| Meeting name | BSC Panel |
| Paper title | Decision on CP1260 - Meter Investigation Process where a Site is Capable of Exporting (microgeneration) |

| Change Proposal – BSCP40/02 | CP No: 1260 <i>Version No: 1.0</i> <i>(mandatory by BSCCo)</i> |

Diagram 1: original BSCP40 issue 2 solution (identical to that presented in DCP v1.0 and v2.0 (option 1));

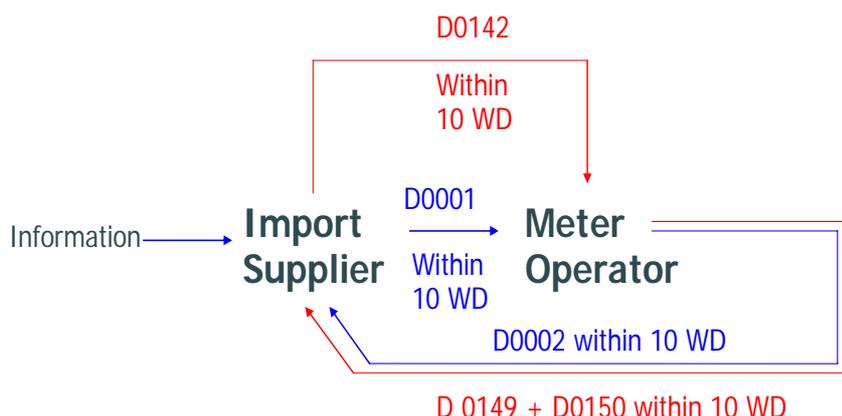
Several comments were raised, most notably the fact that the process was too long. Detailed responses are available at the [DCP0030 webpage](#).

Diagram 2:

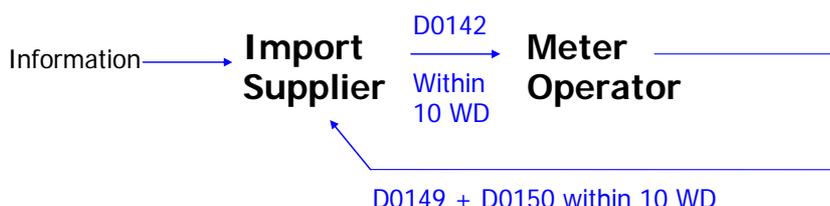
The majority of respondents stated their preference for the D0001 solution (option 3). The reasons provided were that it was a streamlined solution that used investigative flows for the process. Several respondents highlighted that the D0142 (option 2) was not appropriate as the D0142 is a flow which is used to replace meters and cannot be used for investigative purposes. Detailed responses are available at the [DCP0030 webpage](#).

Figure 1(above): illustrates the model as proposed by CP1260.

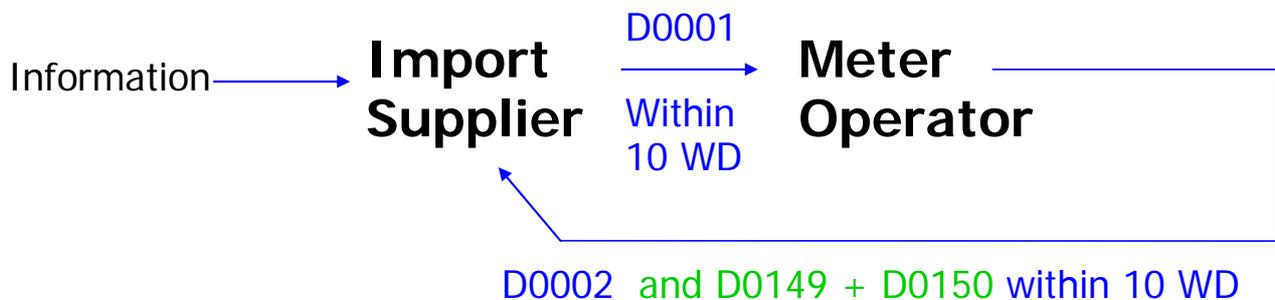
| Scottish and Southern | X | <p>We are not convinced that the D0001 is the correct flow to use. A D0001 flow is to investigate faults/discrepancies on</p> | ✓ | 365 | <p>BSCCo explained that the D0001 was chosen by the</p> |

| | | <p>communication failures A D0142 flow is a request for suitable metering. Following the site visit, a D0002 if meter installed is suitable or a D0149/D0150 if new meter fitted. Not both flows.</p> <p>Impact Changes to system and processes</p> | | | <p>majority of respondents as the preferred solution in DCP0030 consultation.</p> <p>Scottish and Southern have expressed concerns that on a Change of Supplier, the new Supplier may not be aware that customer has equipment capable of microgeneration and remain in disagreement with this CP.</p> |
| Siemens Metering Services | X | <p>As in our previous response to DCP0030, Siemens Metering Services still believe that the D5 flow would be more appropriate than the D1, for the Supplier to request the site visit from the MOA.</p> <p>The D1 flow relates to Meter fault investigations, and therefore it is misleading to use this type of flow in this instance. D1s and D5s are handled differently. If CP1260 is implemented, this will create a need for manual intervention in order to sort through the D1 fault investigation flows to identify those which require visits to identify if backstops are required, or if the meter requires replacing.</p> <p>Capacity in which Organisation is impacted MO</p> <p>Impact on Organisation: Process changes would be required.</p> <p>Would implementation in the proposed Release have an adverse impact? No adverse impact, assuming implementation is February 2009 (above states date as</p> | ✓ | 90 | <p>BSCCo explained that the D0001 was chosen by the majority of respondents as the preferred solution in DCP0030 consultation.</p> <p>BSCCo noted that February 2008 was erroneously reported on the CP response form and confirmed that this CP was due to be implemented in February 2009. However the proposed implementation date has been changed to June 2009.</p> <p>Siemens Metering Services remain in disagreement with this</p> |
